VCS JOINT VALIDATION & VERIFICATION REPORT

Agroforestry Plantations in India

Report ID	22035-VCS
Project Title	Agroforestry Plantations in India
Project ID	3562
Verification period	18-June-2018 to 17-March-2024
Crediting period	18-June-2018 to 17-June-2048
Original date of issue	02/03/2025
Most recent date of issue	25/11/2025
Version	01.3
VCS Standard Version	V4.7
Client	Infinite Environmental Solutions Limited
Prepared by	4K Earth Science Private Limited

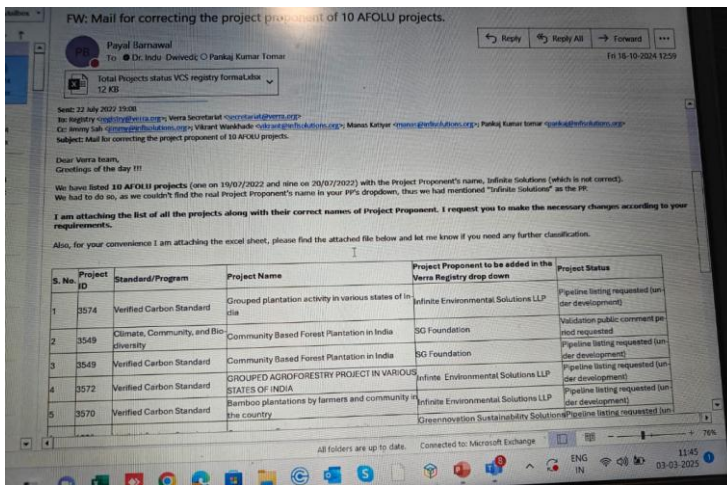
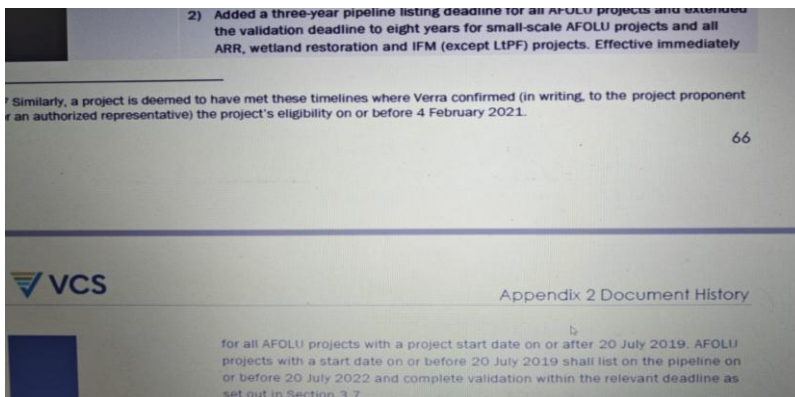
3. The start date justification provides is not in line with the VCS Standard. Per Section 3.8 of the VCS Standard v4.4, the project start date of an AFOLU project is the date on which activities that led to the generation of GHG emission reductions or removals are implemented. PP is requested to justify that how the soil preparation for plantation has been selected as the project start date and how the project is in line with the VCS rules?

4. Per section 3.8.3 of the VCS Standard, v4.7, AFOLU projects shall initiate the pipeline listing process (as set out in the VCS Program document Registration and Issuance Process) within three years of the project start date. PP must justify how the project is in line with section 3.8.3 of the VCS Standard, v4.7 considering the pipeline listing date of the project is 11/09/2023.

1. Infinite has revised the complete documentation of the project based on the updated data received from the PP.
2. The pipeline listing is done per the applicable VCS standard in 2022. The communication with VERRA is being submitted.

The VERRA guidance document says.

The PP has revised the entire PDMR and has now applied the latest version of the template. The justification provided for the project listing is also in line with Appendix 3 of the VCS standard v4.7. No issues found in the revised PDMR section 1.3. Accordingly, the CAR is closed.
